TECHNICAL MEMORANDUM

Re: RI Phase 2 Modification No. 11

Recommended Soil Gas Sampling Locations Nevada Environmental Response Trust Site

Henderson, Nevada

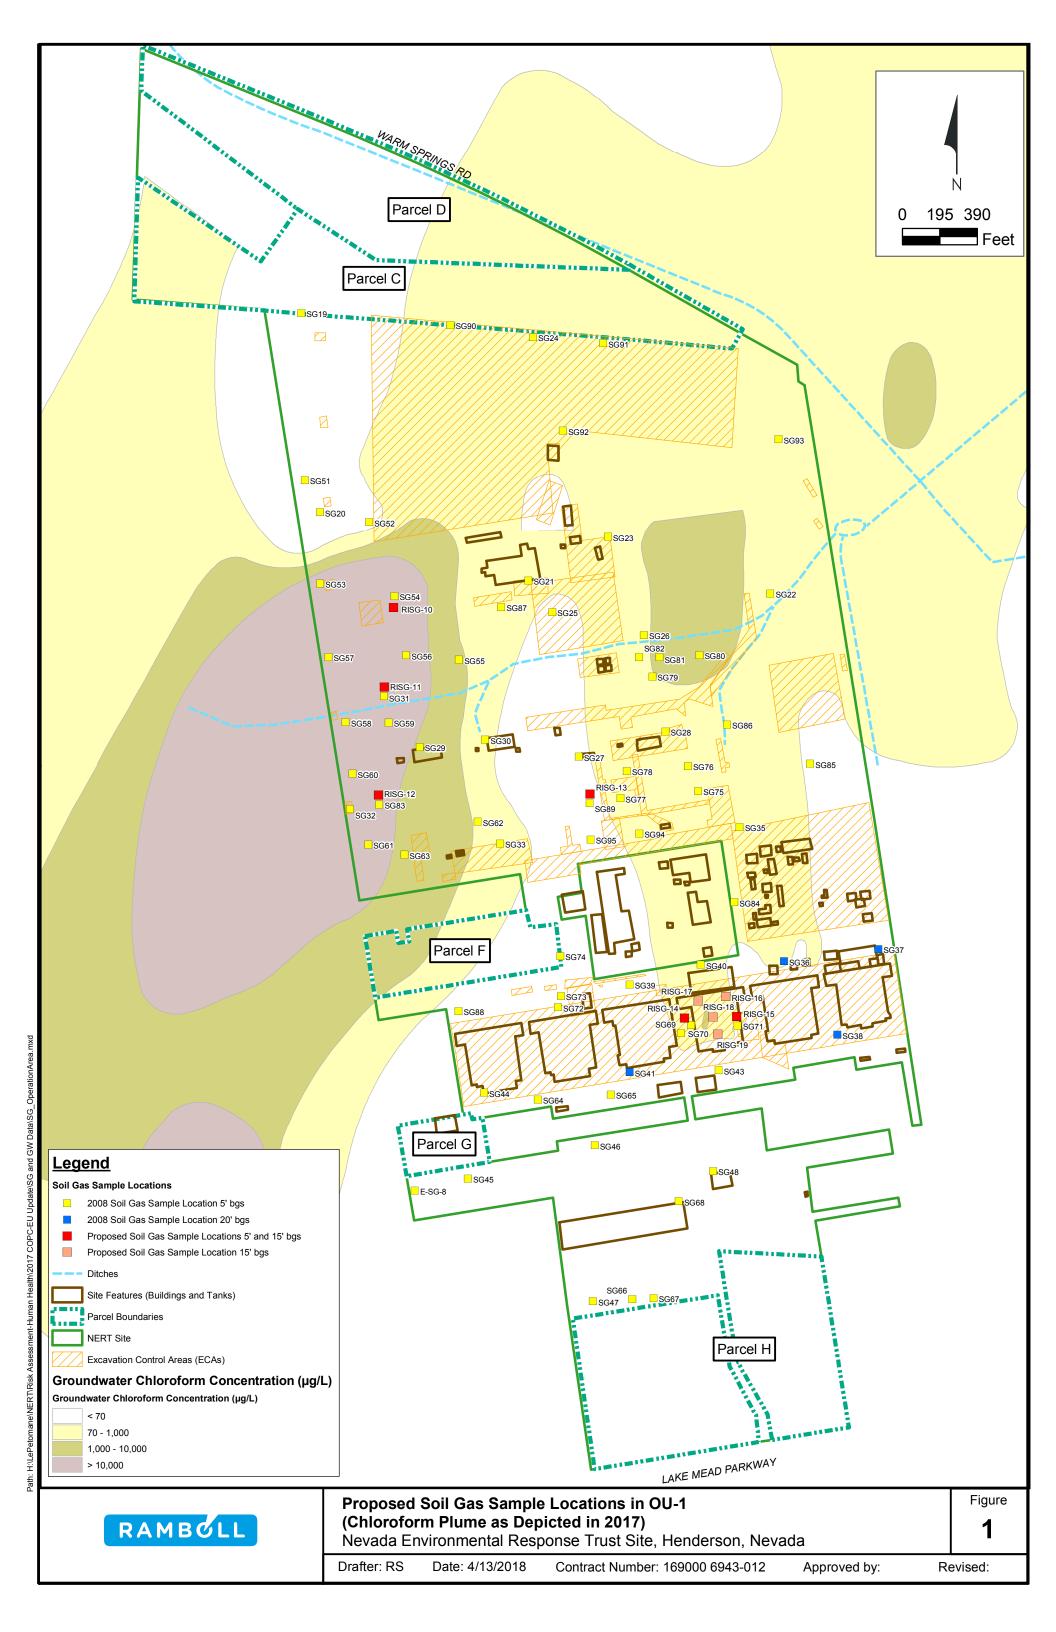
As shown on Figure 1, ten soil gas sampling locations are proposed in OU-1 for the reasons listed above. These sample locations are summarized in Table 1 and discussed in further detail below:

- Three soil gas sample locations (RISG-10, RISG-11, and RISG-12) are proposed to confirm previous soil gas sample locations in the main chloroform groundwater plume area at the western portion of the Site. These locations were selected because they are adjacent to shallow groundwater monitoring wells M-126, M-125 and M-123, respectively. Soil gas samples in these locations were previously collected at 5 feet bgs. It is proposed to collect soil gas samples at both 5 and 15 feet bgs at these locations.

- One soil gas sample location (RISG-13) is proposed in the central portion of the Site based on previous soil gas sampling results (near location SG89, sampled at 5 feet bgs) showing high chloroform concentrations located outside the main chloroform plume area. To verify the previous soil gas sampling results and also to obtain soil gas samples at a deeper depth interval closer to the source (i.e., the underlying groundwater), collection of soil gas samples at 5 and 15 feet bgs are proposed at this location.

- Two soil gas sample locations (RISG-14 and RISG-15) are proposed to confirm previously-reported relatively high concentrations of chloroform in soil gas (at locations SG70 and SG71, sampled at 5 feet bgs) located at the southern edge of the main chloroform plume area near Unit 4 in the southern portion of the Site. M-191 and M-192 are the two shallow groundwater monitoring wells that are co-located with RISG-14 and RISG-15, respectively. To verify the previous soil gas sampling results and also to obtain soil gas samples at a deeper depth interval closer to the source (i.e., the groundwater), it is proposed to collect soil gas samples at both 5 and 15 feet bgs at these two locations.

- Four soil gas samples (RISG-16, RISG-17, RISG-18, and RISG-19) are proposed beneath the currently existing basement slab in the center of Unit Building 4. These locations are proposed based on relatively higher concentrations of chloroform detected in grab groundwater samples collected by Tetra Tech in 2017¹⁰. Previously no soil gas samples were collected under Unit Building 4. To verify the impact on soil gas from the relatively high chloroform concentrations detected in the shallow groundwater under Building 4, it is proposed to collect soil gas samples beneath the basement slab, which is approximately 15 feet below the adjacent ground surface.

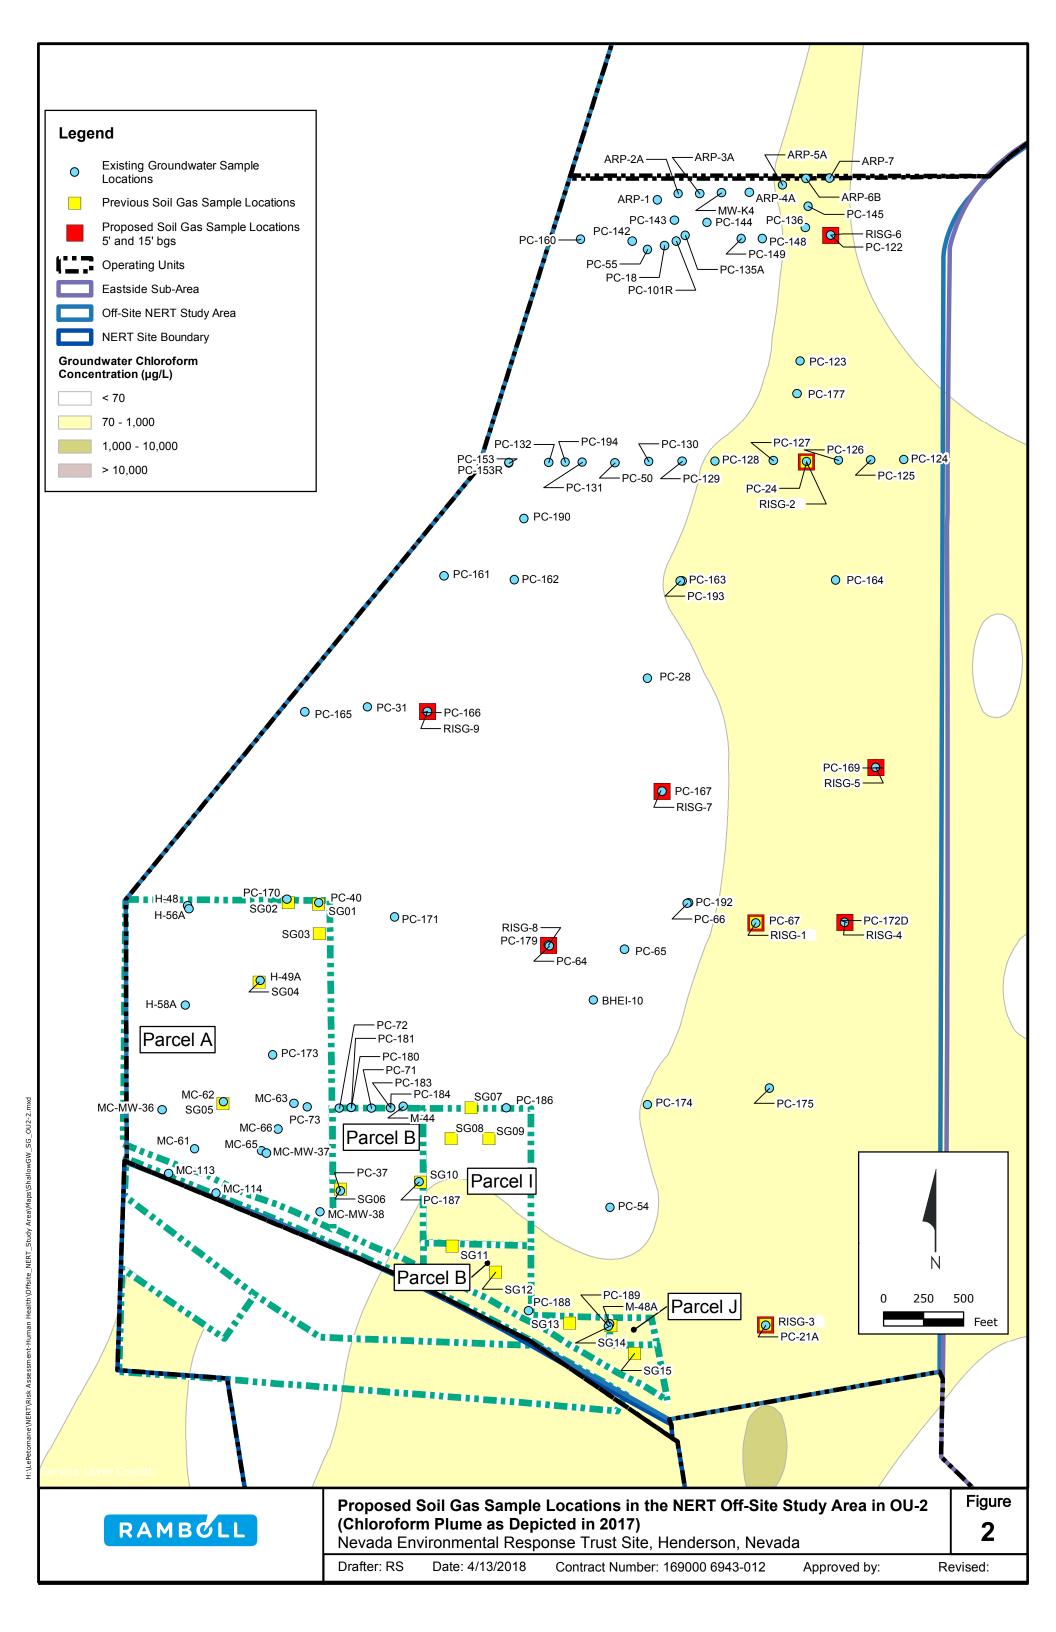
- Three soil gas sample locations (RISG-1, RISG-2, and RISG-3) are proposed at the same locations as the previously sampled locations during the RI Phase 1 Investigation in 2015. These three locations are located in the southern, central, and northern portions of the chloroform groundwater plume extending onto the NERT Off-Site Study Area in OU-2. Resampling at these three locations (RISG-1, RISG-2, and RISG-3) is proposed to confirm previously detected concentrations of VOCs in soil gas. The proposed locations are adjacent to shallow groundwater monitoring wells PC-67, PC-24, and PC-21A and are in the public right of way.

- Three soil gas sample locations (RISG-4, RISG-5, and RISG-6) are proposed to better characterize concentrations of VOCs in soil gas within the groundwater chloroform plume downgradient of the Site. The proposed locations are adjacent to shallow groundwater monitoring wells PC-172D, PC-169, and PC-122 and are in the public right of way.

- Three soil gas sample locations (RISG-7, RISG-8, and RISG-9) are proposed to better understand the lateral extent of VOCs in soil gas downgradient of the Site.
 The proposed locations are adjacent to shallow groundwater monitoring wells PC-167, PC-179, and PC-166 and are in the public right of way.
